**1958 Agreement – Consideration of draft amendments
to existing Regulations submitted by GRRF**

Proposal for Supplement 5 to the 01 series of amendments to Regulation No. 55 (Mechanical couplings)

Submitted by the Working Party on Brakes and Running Gear*

Figure 25 a

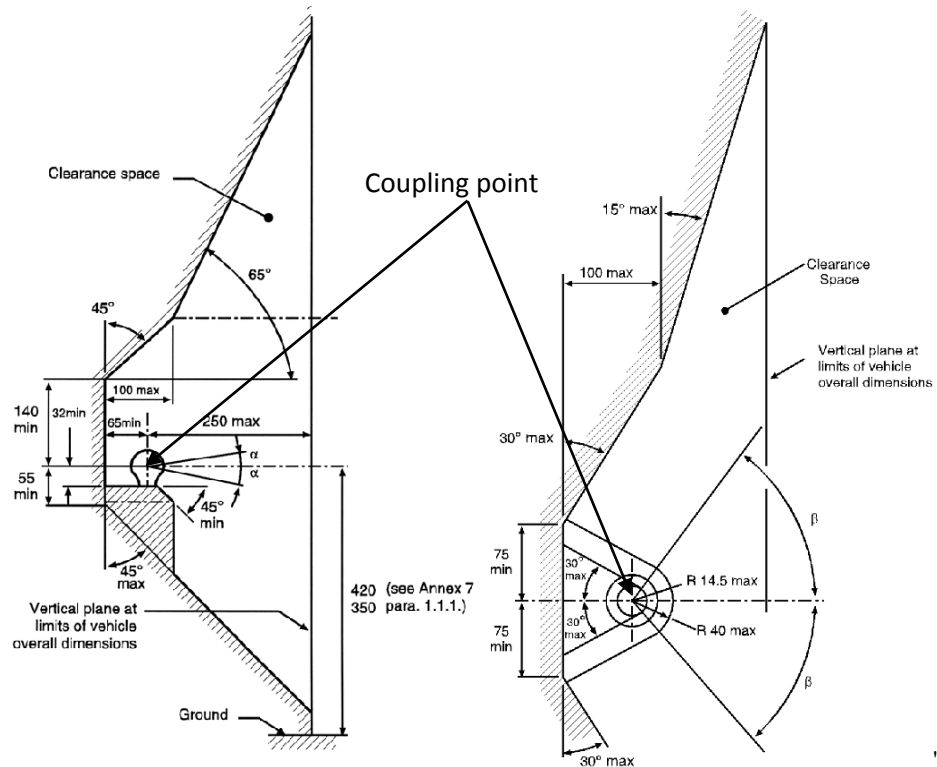
- 1.1.1.1. The clearance space shown in Figures 25a and 25b may be occupied by non-demountable equipment, such as a spare wheel, provided that the distance from the centre of the ball or the centre of the hook on a vertical plane at the extreme rearmost point of the equipment does not exceed 250 mm. The equipment shall be mounted to allow adequate access for coupling and uncoupling without risk of injury to the user and without affecting articulation of the coupling.

- is rotated horizontally 60° to right or left, ($\beta = 60^\circ$, see Figure 25);
- is rotated vertically 10° up or down ($\alpha = 10^\circ$, see Figure 25);

1.2.2. It shall be possible to operate the coupling heads/ toroidal drawbar eyes safely within the free space of the coupling ball/hook coupling given in figures 25a and 25b, up to angles of $a = 25^\circ$ and $b = 60^\circ$.
